**Subject: Assumption of Geotechnical Engineer of Record, Geotechnical Update, and Response to City of San Diego Review Comments (PRJ- 1132845)
Bunker Hill Multi-Dwelling Units
2917 Bunker Hill Street, APN No. 424-321-21-00
San Diego, California 92109**

Response to City of San Diego Review Comments (PRJ-1132845)

GEOTECHNICAL MAP

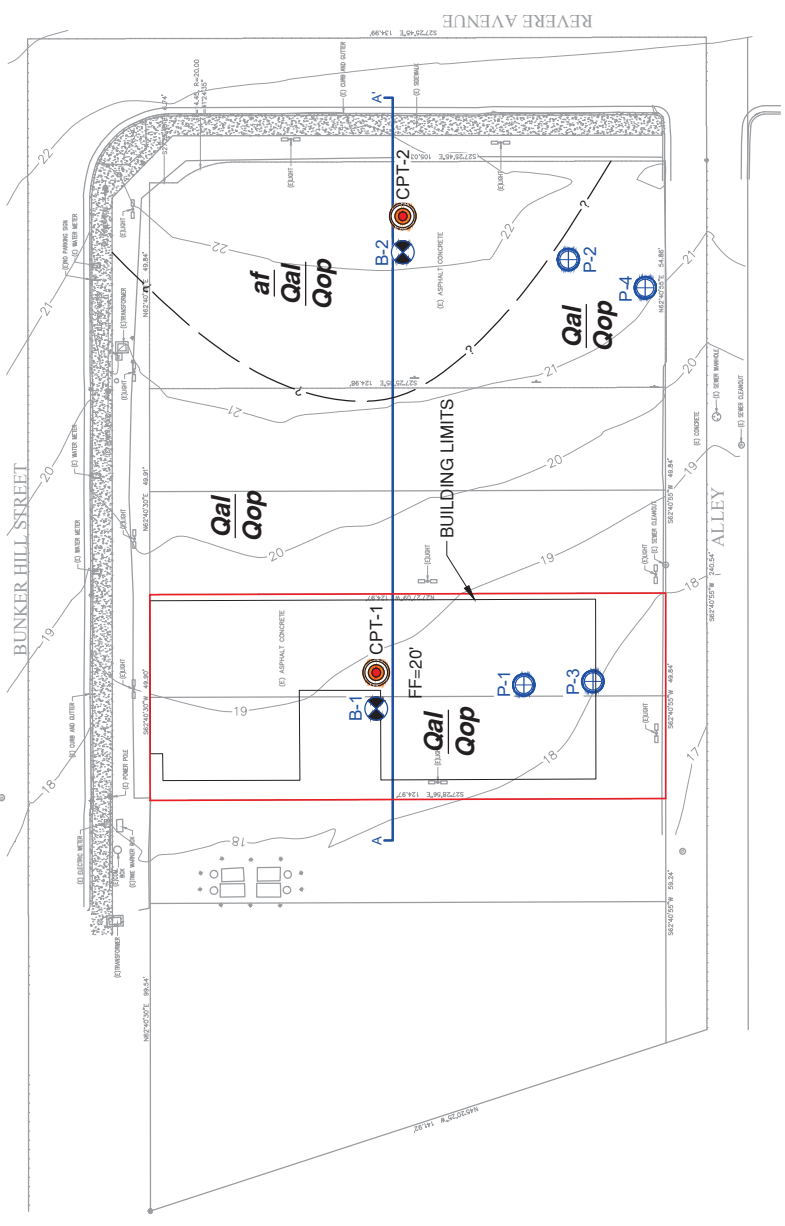
Comment 39: *The geotechnical investigation report must contain an updated site-specific geologic/geotechnical map that shows the distribution of fill and geologic units, that depicts geologic structure (bedding, joints, landslide structure, etc.), and the proposed development. Circumscribe the limits of recommended remedial grading to provide the limits of the project.*

Response: The attached Figure 2 depicts

CPT file : CPT-1

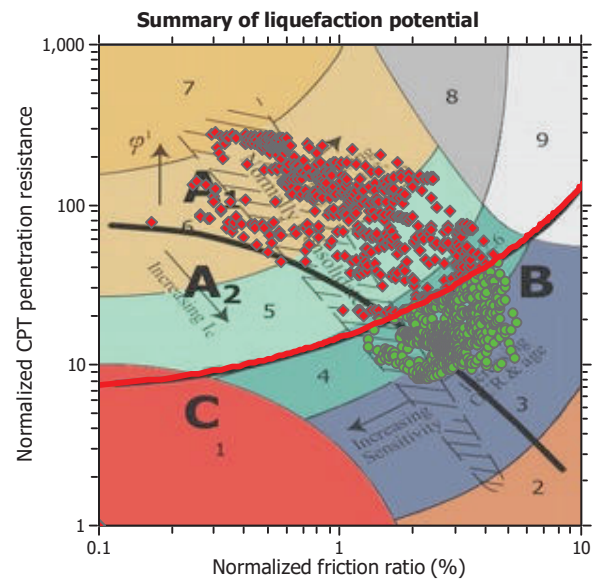
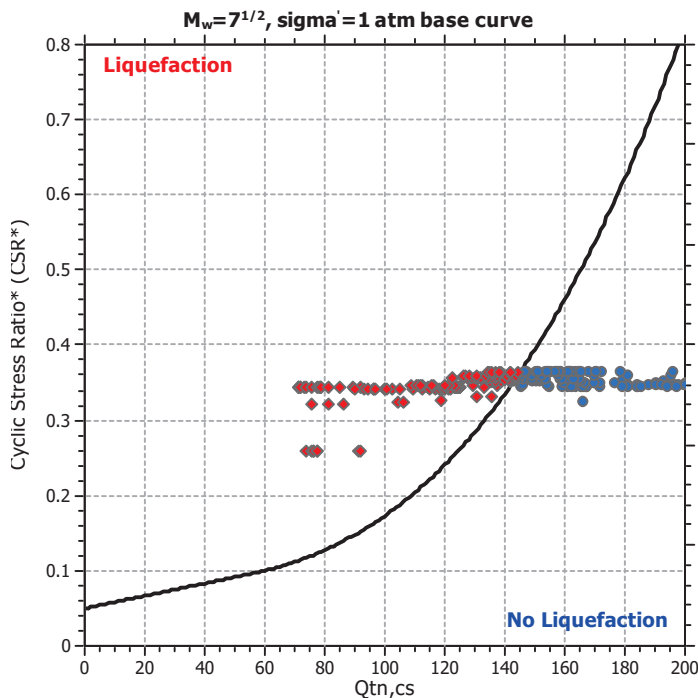
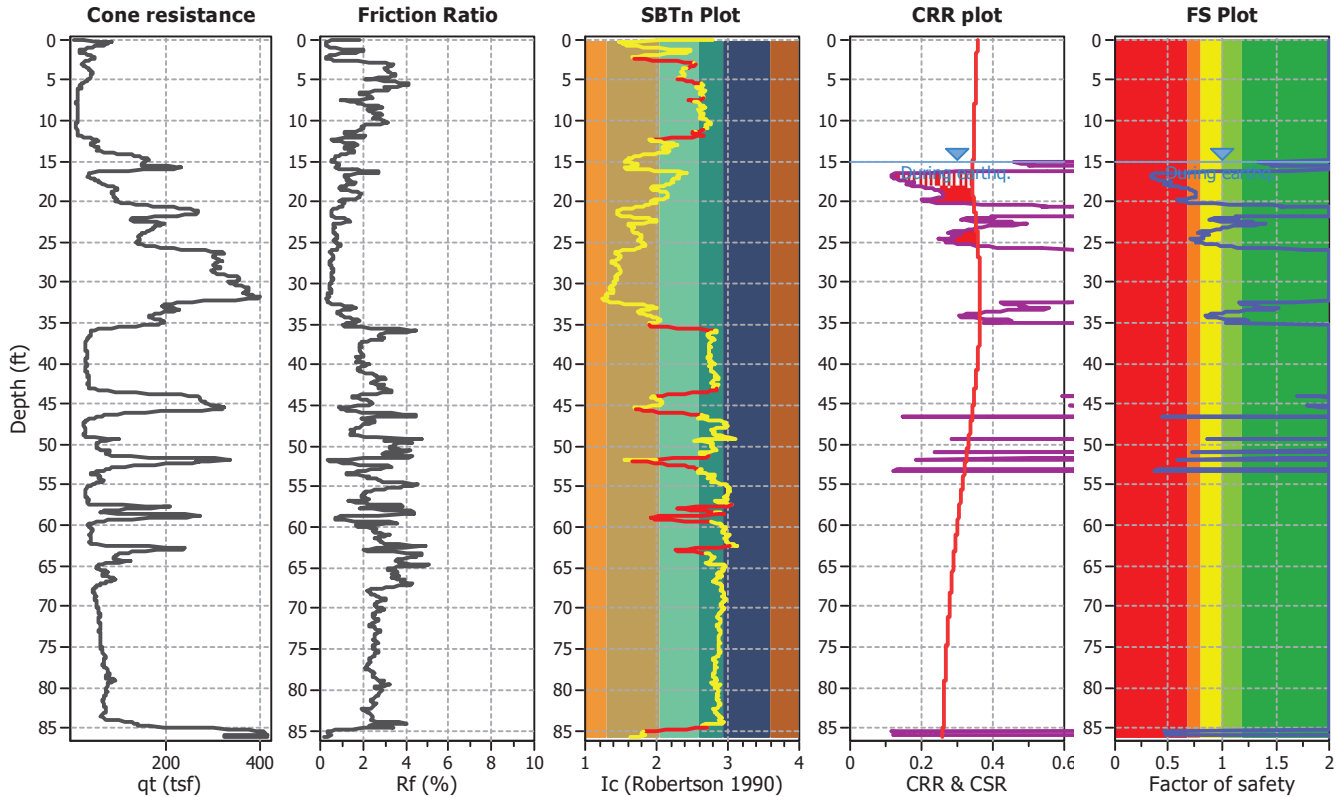
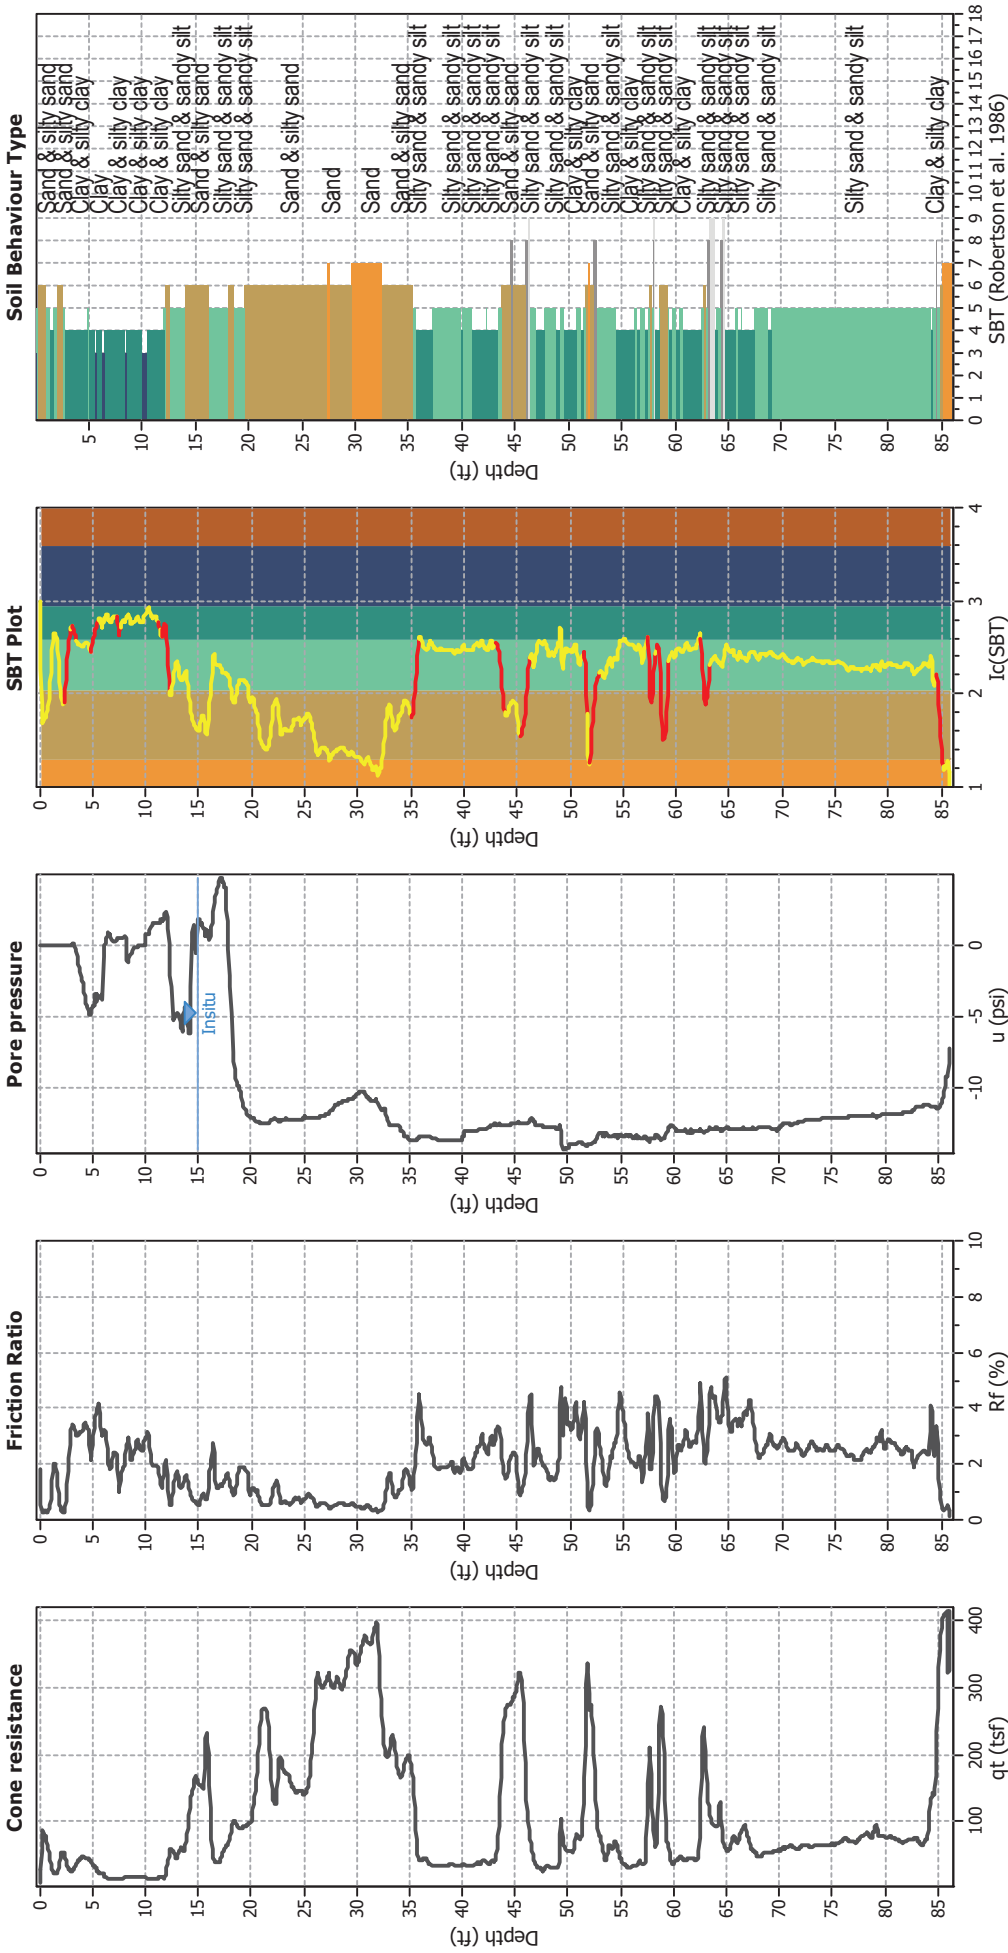
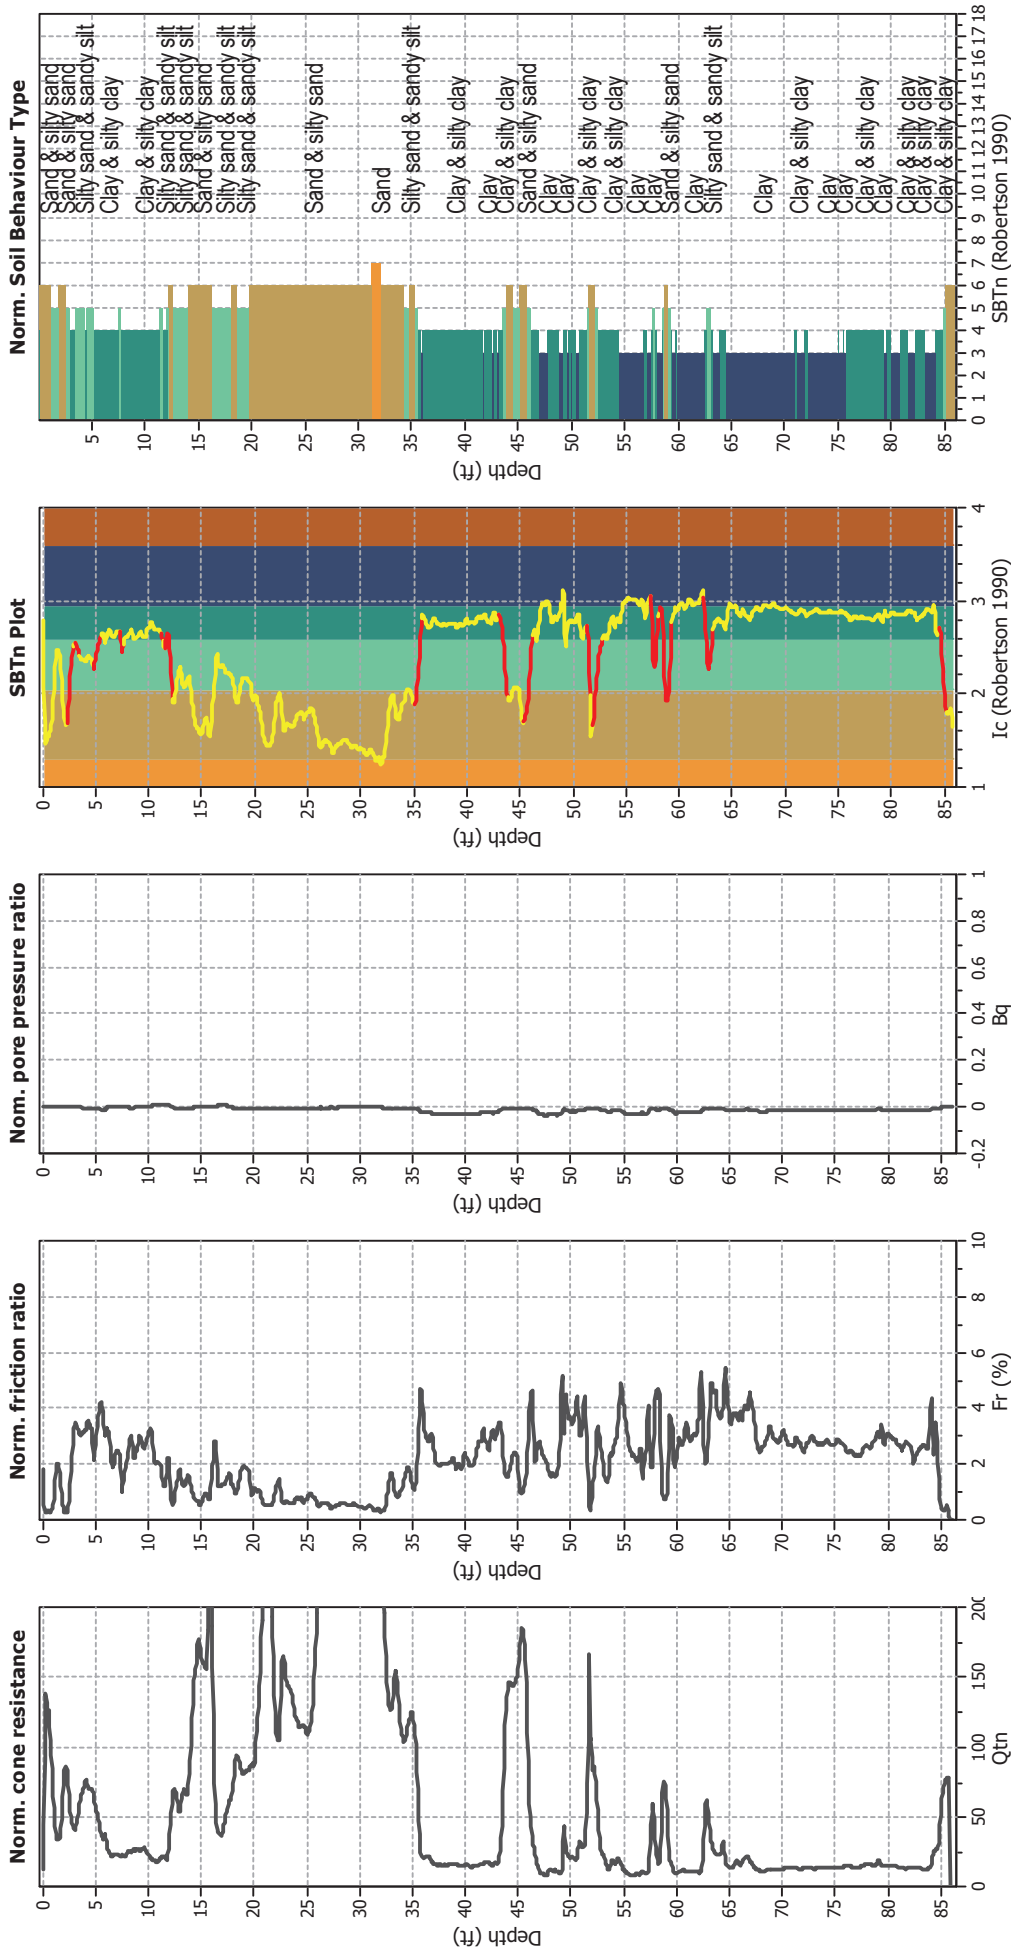
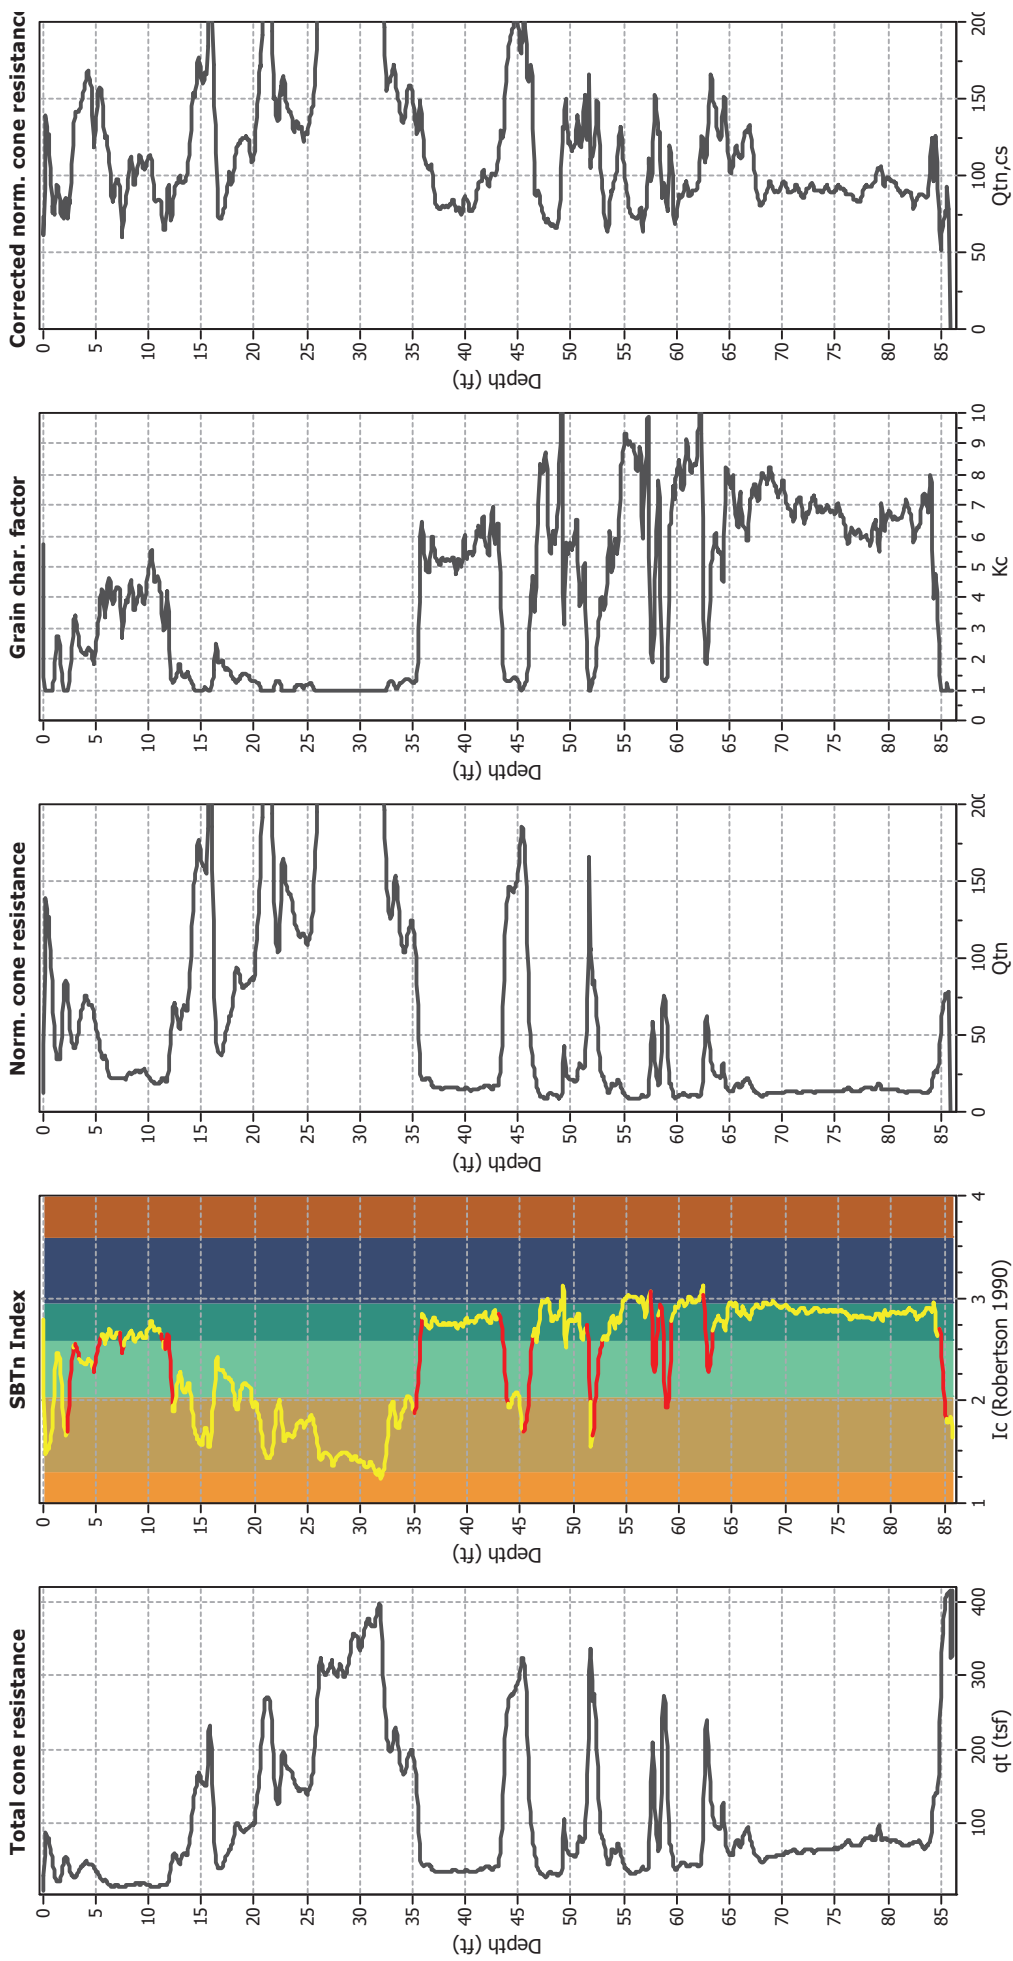
Comment 40: *Explain why the depth of the liquefaction analysis was limited to 30 feet for CPT-1.*

Response: Following review of the referenced geotechnical report (NOVA, 2023a), it appears the material below a depth of 30 feet (Old Paralac Deposits) was assumed to not be liquefiable based on the geologic age of deposition, which is of the early Pleistocene. However, based on our review of the geotechnical investigation, including blow counts and CPT sounding results, we believe the Old Paralac Deposits are susceptible to liquefaction and should be included in any liquefaction analyses. The revised liquefaction analyses are presented in Appendix A and did not limit the depth of the liquefaction analysis.
